**Addendum 2
Invitation to Bid (ITB)
No. P17926-2024-03-27**

BUILDING E RENOVATION / ALLIED HEALTH

**Rogue Community College District
Redwood Campus, Grants Pass, Oregon**

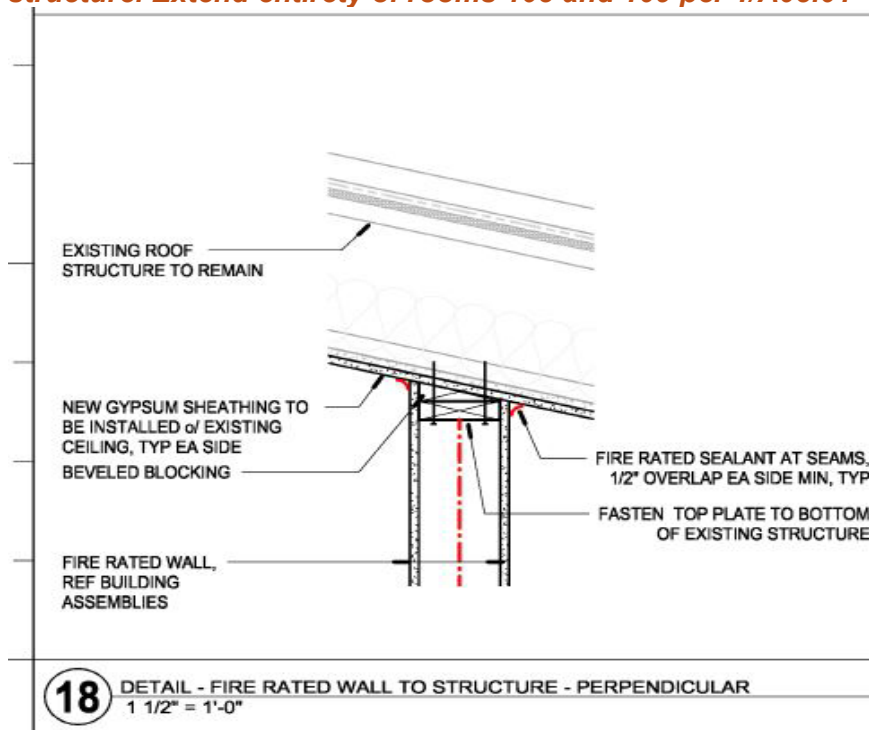
2. Detail 18-A09.11d states that a layer (1) of 5/8X is to be applied over the existing ceiling. How far back does this drywall extend? On both sides of the walls as it pertains to this detail. See the detail below.

Detail should show two new layers of gypsum board attached to existing roof structure. Extend entirety of rooms 103 and 109 per 1/A08.01
